Design Statement

Proposed Development at Firhouse Inn

Firhouse Road, Dublin 24

Project: Firhouse Inn
Location: Mortons Inn Firhouse, Firhouse Rd, Dublin 24
Client: Bluemont Developments (Firhouse) Ltd.
Doc. Title: Design Statement
Doc. No.: 20022B-OMP-XX-XX-RP-A-91000

4 | General Arrangement + Layouts

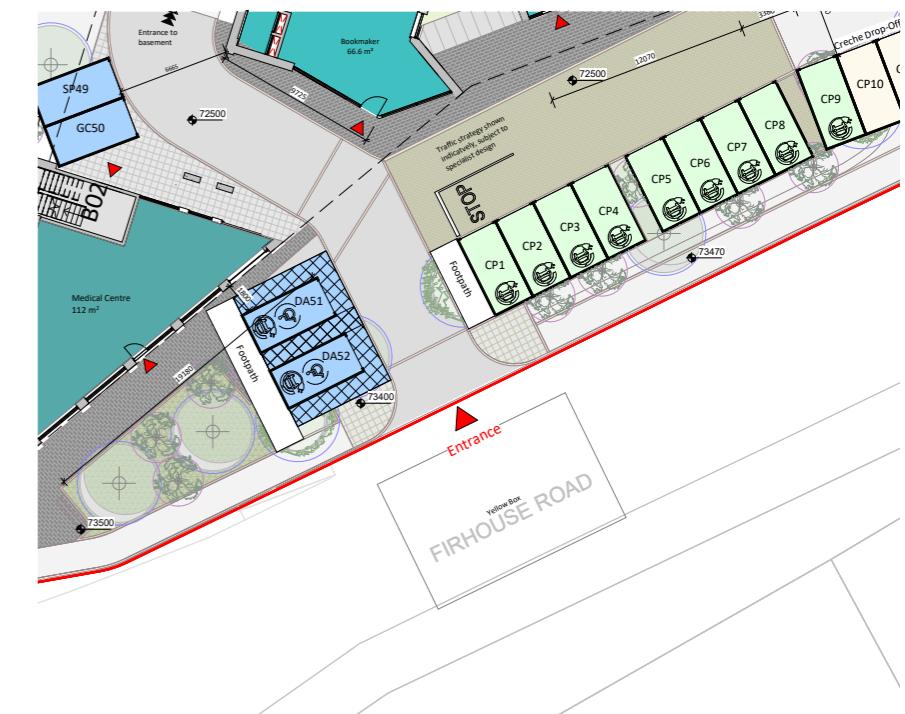
Adjustment of Floorplan Layouts

Minor amendments to the general arrangement layouts are also proposed, so that the floorplans stack better, for ease of construction and to satisfy fire safety requirements. No change to overall footprint however the unit mix has been revised.

Surface Level Parking Provision

To satisfy the requirements and concerns of future tenants of the commercial units, carparking at surface level is proposed. This includes an accessible carparking space in front of the medical centre and adjacent to the public open space, to ensure ease of access if required.

The proposed parking layout would still accommodate the waste collection strategy as per the previously permitted scheme, and the overall parking provision is retained.

Elevation Study

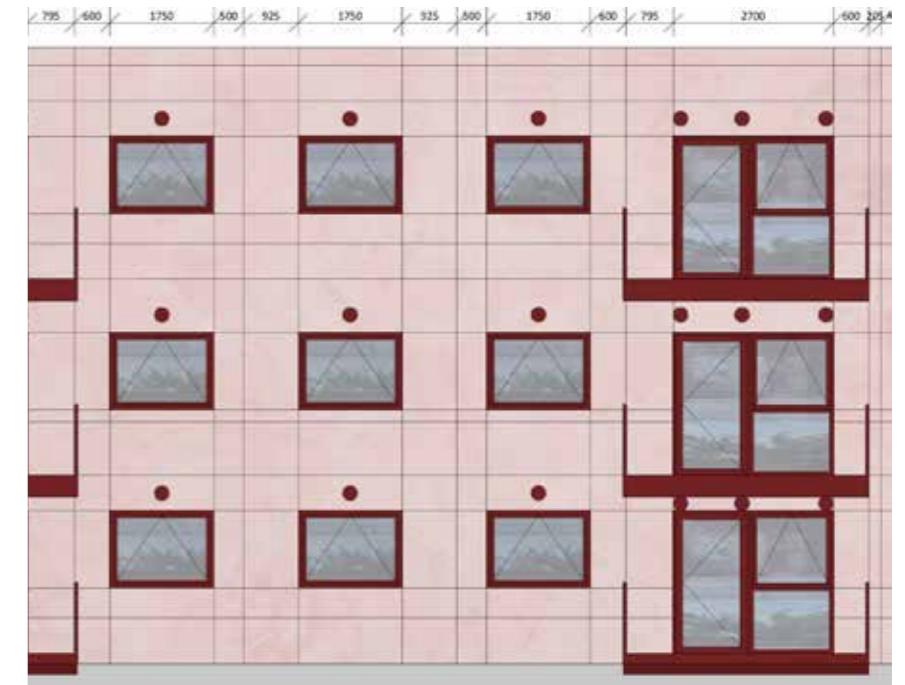
Architectural Expression of the Construction Methodology

The precast facade panel method of construction ensures factory condition quality control and efficiency of delivery.

Each facade will be comprised of panels and joints. The size of each panel depends on the capacity and position of the crane, relative to the final location of the particular panel, and so does the position of each joint.

To streamline coordination and ensure maximum flexibility in the placement of panel joints, the elevation strategy embraces the

joint as architectural feature, and generator of a modular grid. Expressed on the facades, the grid is established by way of separation, repetition and symmetry, generated from required datums, distances and relationships between fenestration and ventilation elements, and horizontal and vertical axes of alignment.

This results in a subtle detail that adds scale and visual interest to the repetitive rigour of the facade of the residential blocks.

Architectural Elements as Features

To align with the graphic nature of the facade grid, monochromatic facade elements are proposed. Window and door frames, ventilation grilles, balcony balustrading would be colour matched to each other and contrast the gridded background of the facade, resulting in a contemporary character generated from the method of construction.
